Community Association Response

LCO 2021-0135 716 -37th St SW. RC-2 to MU-1 with Road Closure.
Submission deadline 2021 Oct 27th

Spruce Cliff

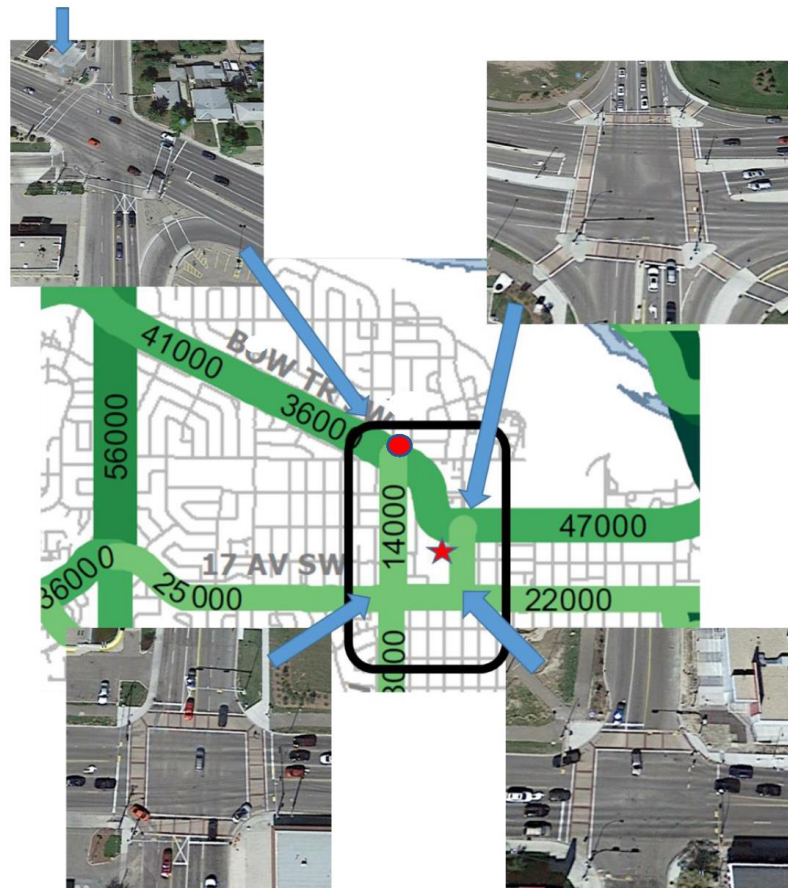
The community shares the Activity zone of the Westbrook LRT, the area south of 8th Ave SW. The property of this LOC application is on the outer edge of the 600M radius and the intersection was therefore not improved per the other three during the 2012 LRT project. (Red oval)
